THE CHARTER

OCT 2025 NMA PACK

GRAVESEND

Existing E01 North Elevation (NMA ref: 20210305)

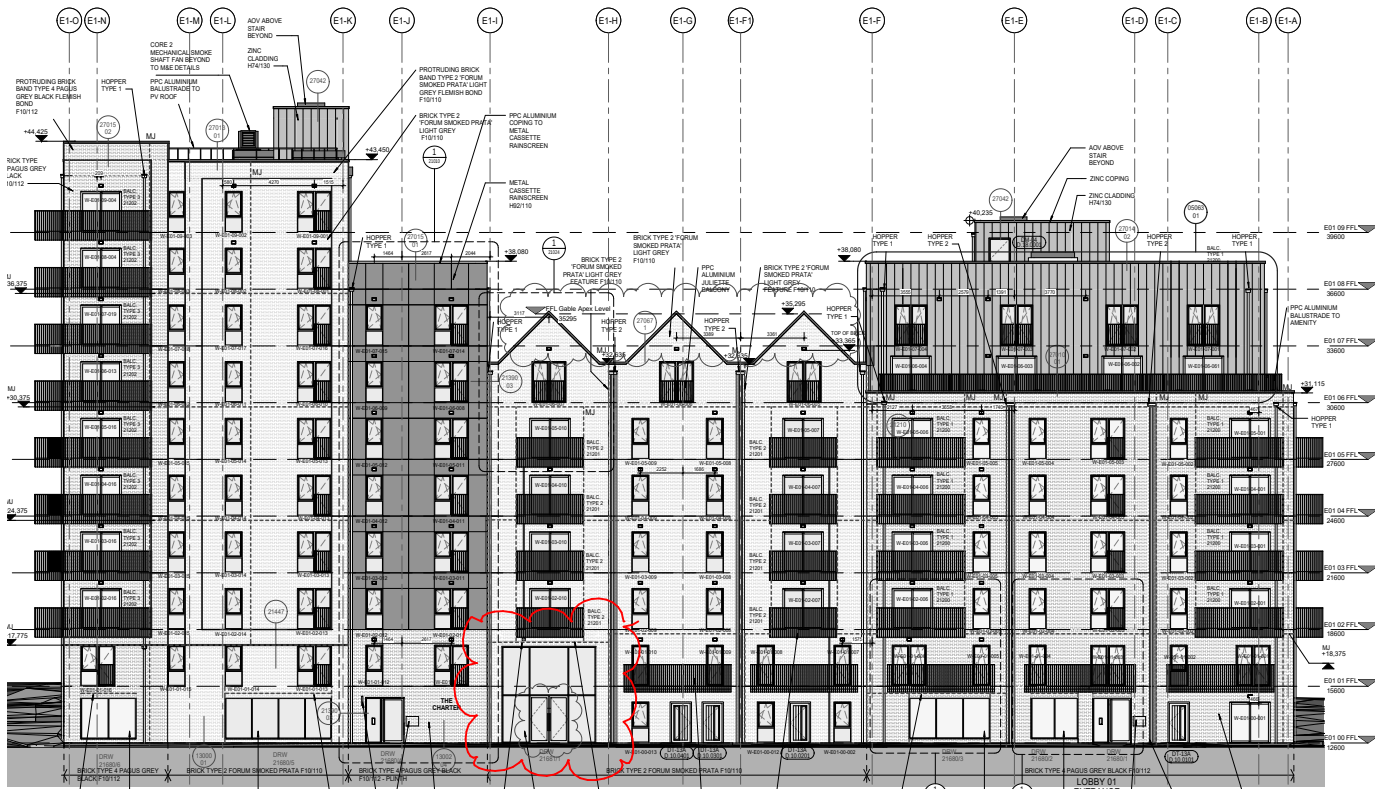
Two new glazed double access doors will be provided on the north and south facades of the double-height flexible event space on the ground floor (Level 00) of Block E01 adjacent to Bank Street. The doors will be part of the full-height glazed wall systems previously consented. This proposal also removes the need for the external gates which were previously shown on the Bank Street elevation which are no longer required.

Existing E03 East Elevation (NMA ref: 20210305)

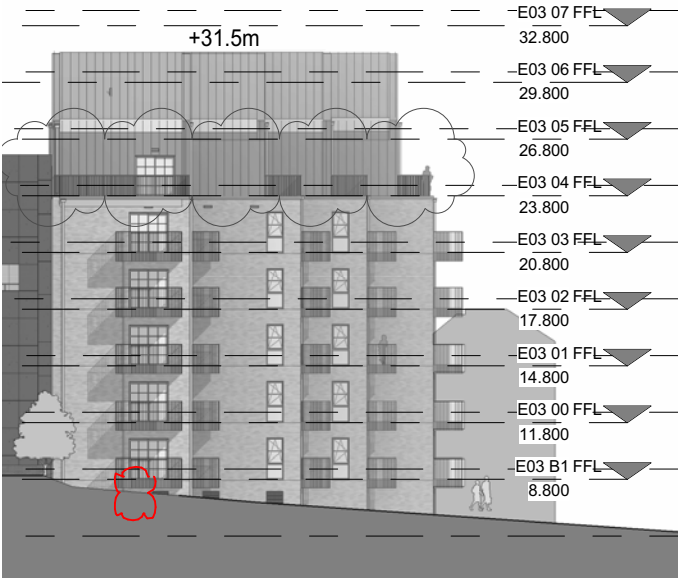
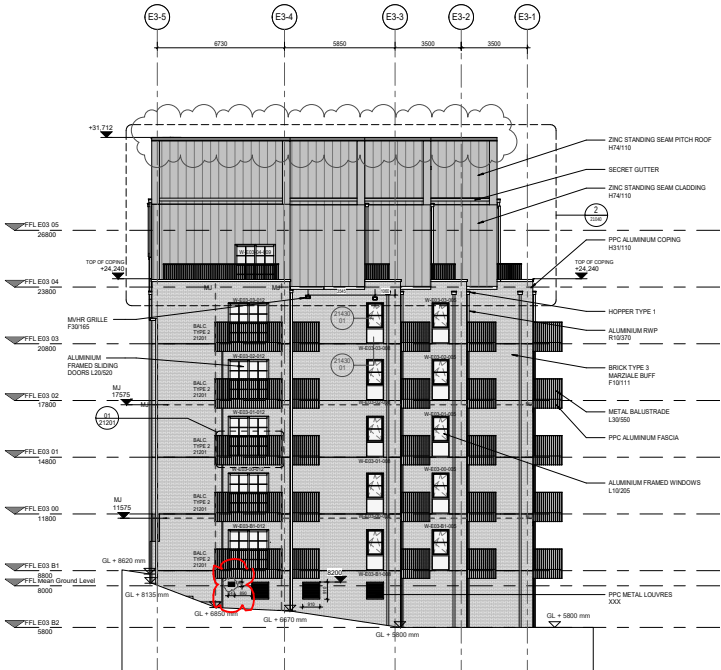
An additional small louvre has been added to the east and west elevations of Block E03 at ground level to provide required natural ventilation provision to internal areas on Level B2 (ground level at Crooked Lane).
